CNL-14-142

**Subject: WATTS BAR NUCLEAR PLANT (WBN) UNIT 2 – RESPONSE TO  
REQUEST FOR ADDITIONAL INFORMATION RELATED TO RELIEF  
REQUESTS ASSOCIATED WITH UNIT 2 INSERVICE TESTING (IST) AND  
PRESERVICE TEST PROGRAMS (MF4118)**

**Responses to Request for Additional Information Related to Relief Requests Associated  
with Unit 2 Inservice Testing (IST) and Preservice Test Programs (MF4118)**

Brookshire, Texas  
Customer: Chattanooga Svc. Center  
Job# 100055823, TC-15064, Rev # 0  
PO: 4500205719-0, S/N: 436945, Fluid: Water  
1775 RPM

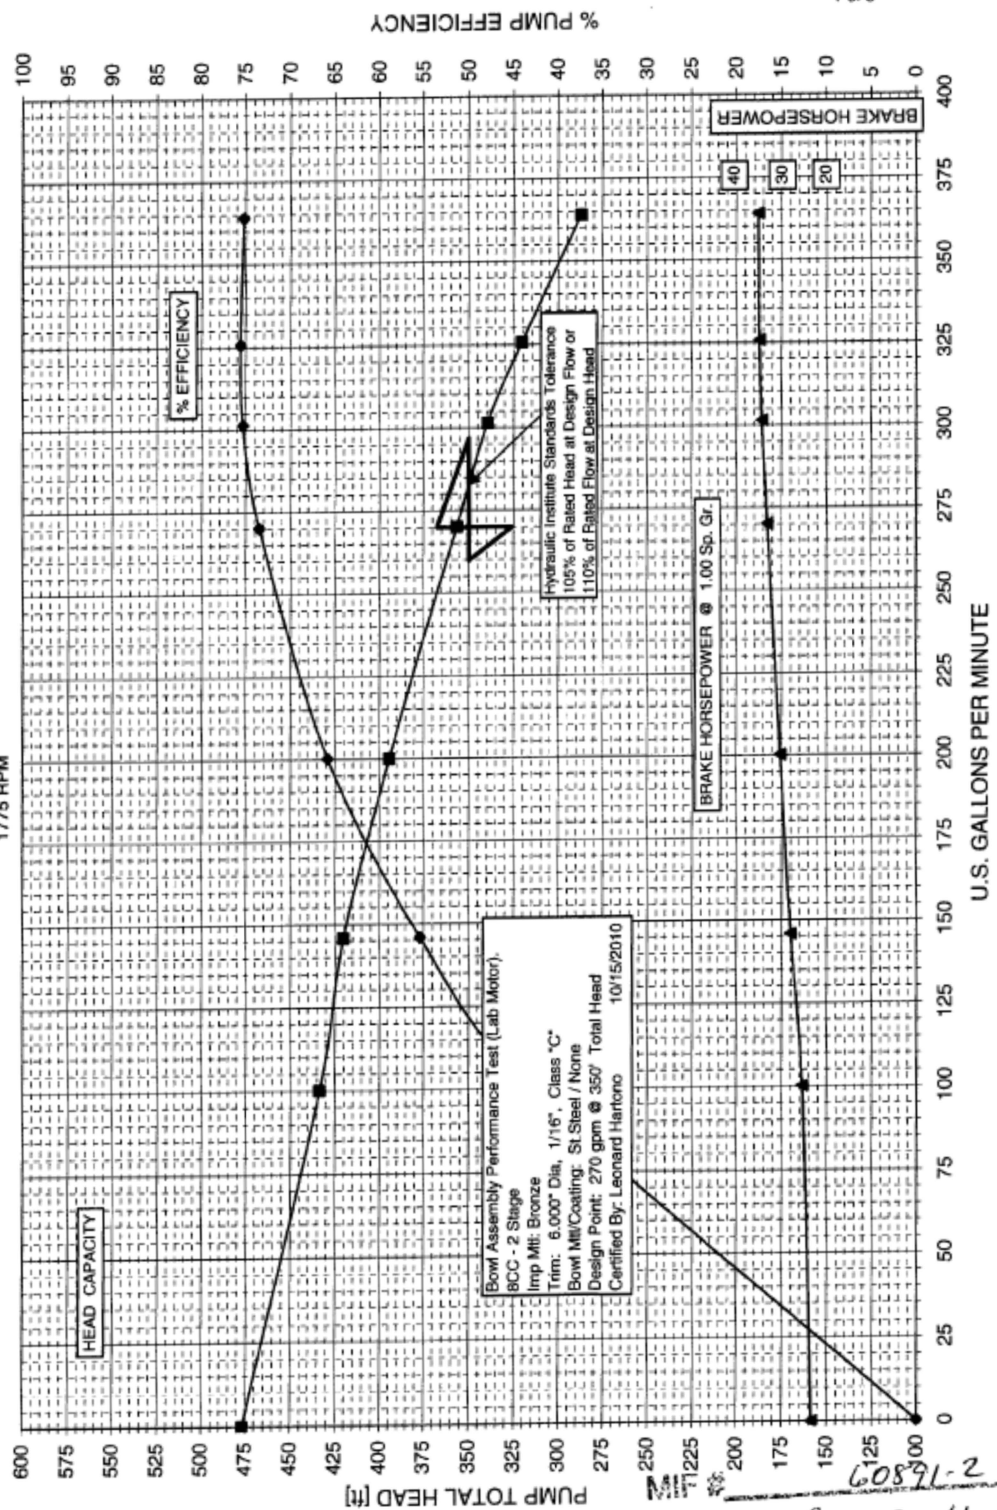
*“For Pump Relief Request IST-RR-2, you state that preservice test data for differential pressure and vibration data will be evaluated to verify that it represents acceptable pump operation. Please explain how this will be done. Also, provide the manufacturer’s pump curve for the ERCW Screen Wash Pump (pump ID 1-PMP-67).”*

The U1 1A pump has been replaced by a replacement model (S/N 434485) from Sulzer. The U1 1B pump is scheduled to be replaced in the near future, also with a replacement Sulzer model (S/N 436945). The U2 2A and 2B pumps are the original Johnston models (S/N NJ-1762 and NJ-1764, respectively). Available pump curves for the original and replacement pumps are attached.
